KENWOOD

ASB-1049

Service Bulletin

Subject: TS-850S "Click Noise" with Notch On

X48-3080-00 Foil Side View

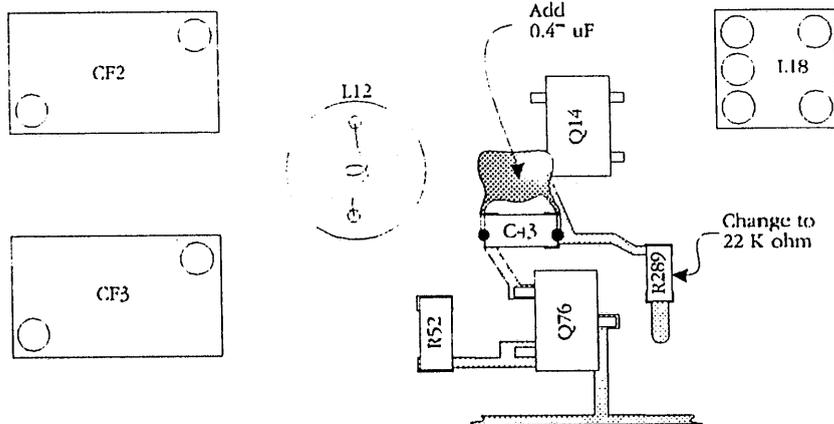
When a strong signal of S-9 or greater is received at the antenna terminal with the NOTCH circuit ON a "clicking" noise might be noticed. This is caused by excessive response in the AGC loop circuit.

The changes detailed below will add additional delay to the AGC circuit and reduce or eliminate this tendency.

Qty	Description	Old Part No.	New Part No.	Circuit Description
1	22 k Ohm chip resistor	RK73FB2A103J	RK73FB2A223J	R289
1	0.47 uF capacitor	NA	CQ92M1H474K	NA
